SERVICETEKNOTES

SC 904
492

TABLE OF CONTENTS

SPG2 OPT. AA EQUALIZING PULSE ROLLOFF

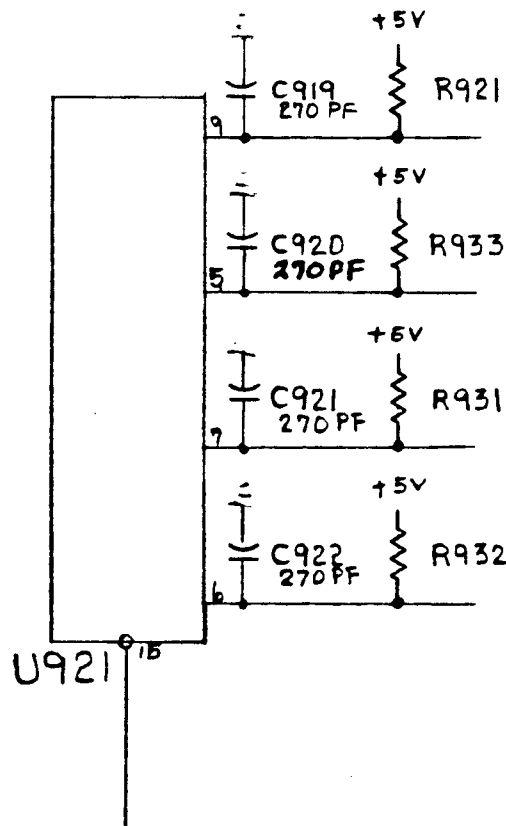
A cable crosstalk problem has been found to cause rolloff problems in the equalizing pulses from an SPG2 Opt. AA.

1. Locate the 10-wire ribbon cable that connects the front panel dual variable pot (R152) to the circuit board (J454/455).
2. Carefully separate this cable into two pieces along its entire length between the green and blue wires.
3. Carefully separate the blue wire from its cable half and dress away from the remainder of the ribbon cables. The separation distance is not critical. The slightest amount seems to help.

SPG 2/12/22 LINE TO LINE JITTER PROBLEM

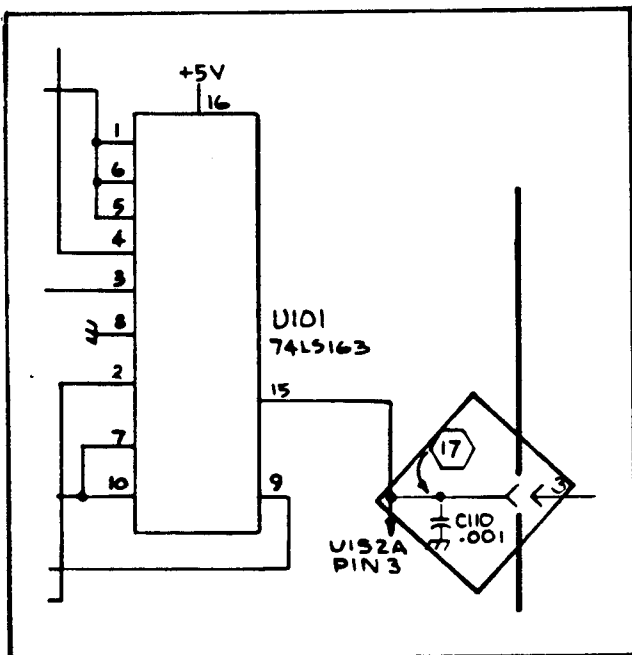
If you happen to notice a line to line jitter at one particular setting of the internal Horizontal Delay switch, an easy correction is available.

A 1000pf capacitor (P/N 281-0812-00) has been added between ground and interface pin 3 on the Sync Timing

board (A2) similar to the illustration below.

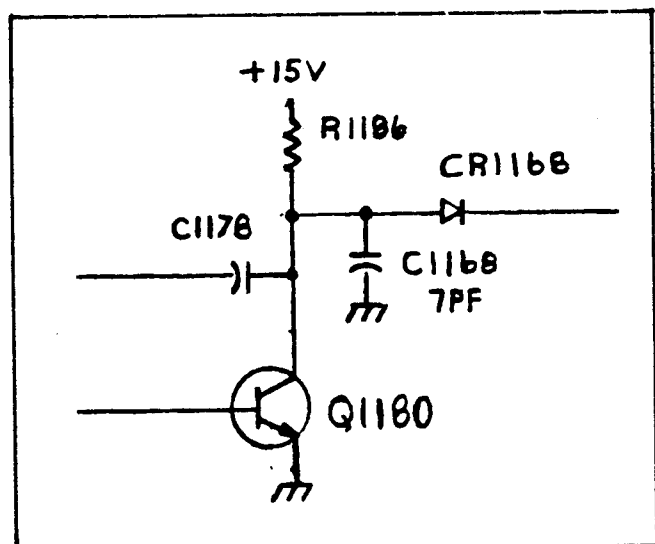
Item 1 was addressed by changing C1662 on the demodulator board from .01ufd to 87pf (283-0632-00). Kits have been set up for replacement of Y1670 or CR1663 that include the new part as follows:

Item 2 was addressed adding a 7pf capacitor, C1168 (283-0157-00) between the anode of CR1168 and ground on the circuit board (see schematic change below). Kits have been set up for replacement of Q1032 or Q1082 (050-1992-00) which includes the new capacitor.

Figure 1. Location of FT1.

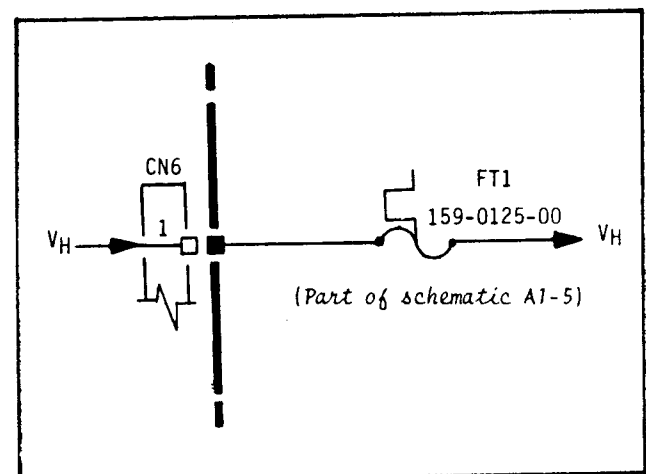
The thermal fuse, FT1 was added to production units to shut down the 300 volt supply to the control board in the event of elevated temperatures. The part number of this thermal fuse is 159-0125-00 and its circuit location is given in Figure 1 below.

Figure 2. O-rings added.

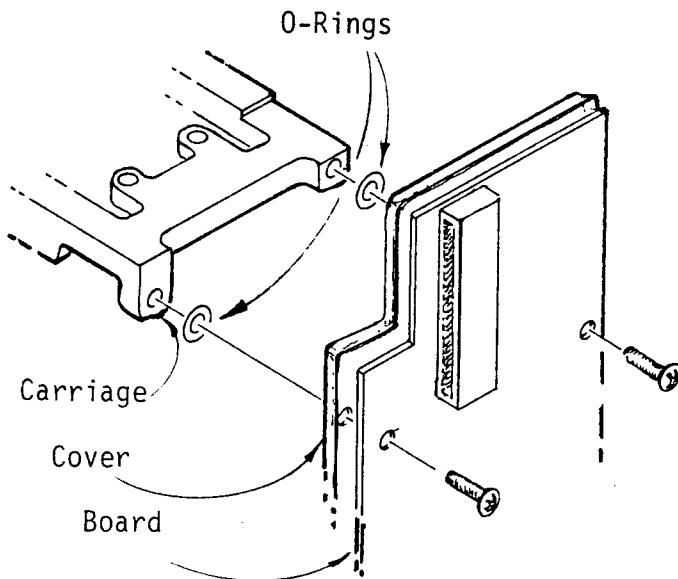
Finally, O-rings were added between the ink head carriage and the interconnect board around the two board mounting screws. See the detail in Figure 2 for the O-rings' locations. This was done to reduce the likelihood of ink

migrating along contact surfaces and finding its way onto the interconnect board. Once on this board, the conductive ink would short the runs causing a control board failure, particularly during an electronic purge.

Figure 3. Addition of R91.

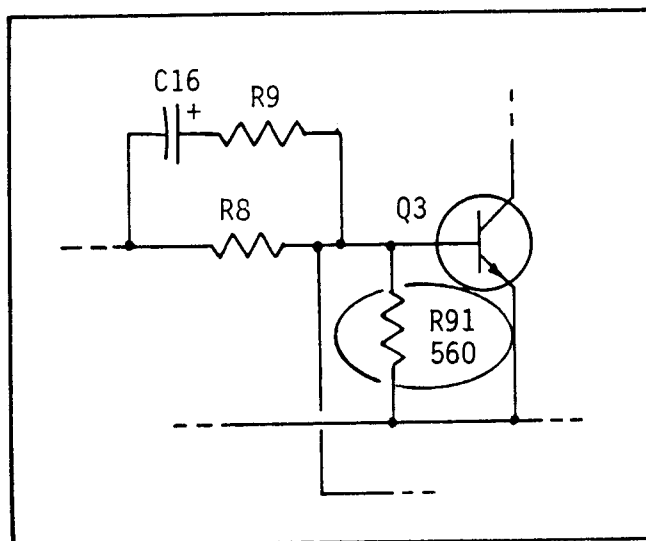
Effective J016635 through J017634, and after J018706, a .5 watt, 560 ohm resistor is added to the power supply board as R91. This part is added as shown in Figure 3 to assist in a clean "power down" of the +5 volt supply. This change is documented as the other part of engineering change order 54907.

Ct. No.	Old	New	Part Number
R70	8.2K	12K	315-0123-00
R90	1.5K	2.2K	315-0222-00
R91	--	560 ohms	315-0561-00

Figure 4. Plastic Spacers

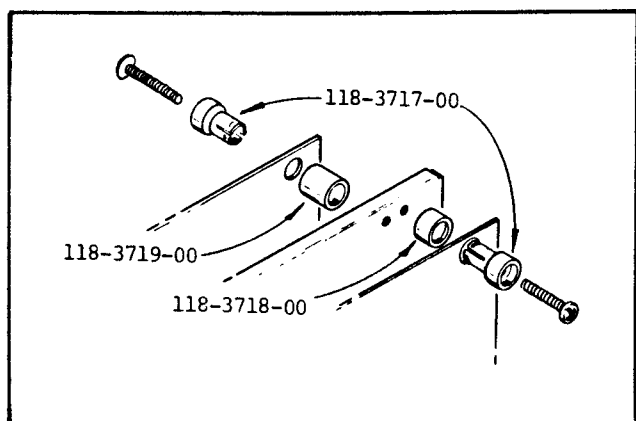
The plastic standoff bushings shown in Figure 4 were originally unavailable as separate components. However, the need for their availability to repair power supplies and control boards prompted change number 53129. Each board uses three 118-3717-00 male bushings. In addition, the control board uses three 118-3719-00 female bushings and the power supply uses three 118-3718-00 female bushings.

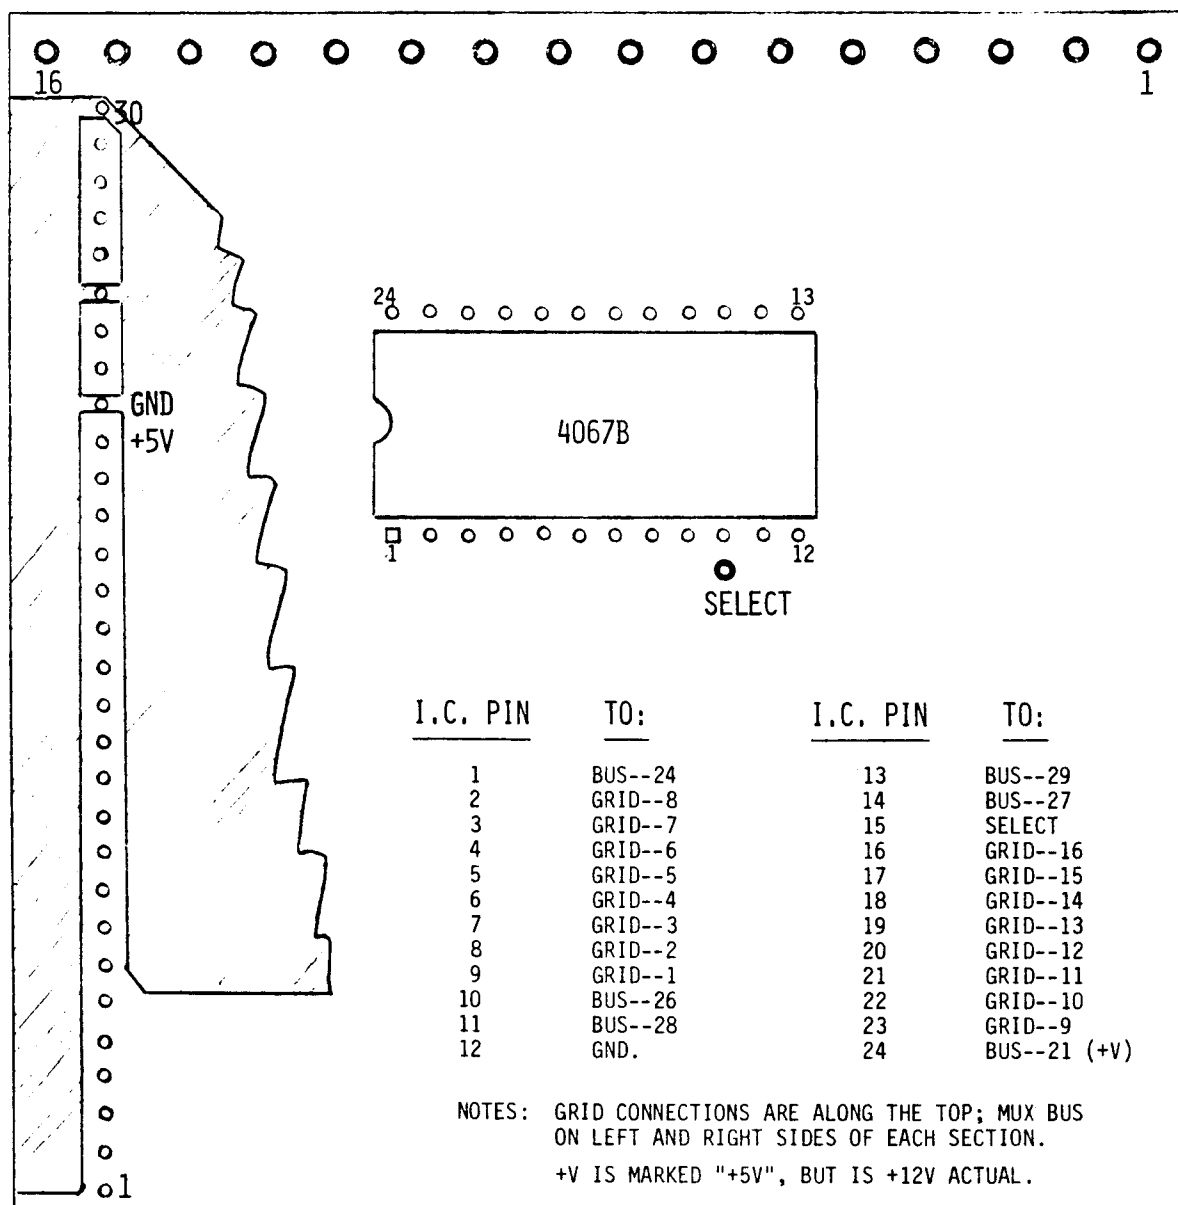
The schematics in the 4958 Service Manual do not include the connection information for the 4067B grid current multiplexers that are spaced along the top and left side of the tablet

So, if you suspect an open connection between an IC pin and a grid connection, an ohmmeter check will tell you if it is really open--and if the IC pin tests open, use the figure below and patch with 30-gauge insulated wire.
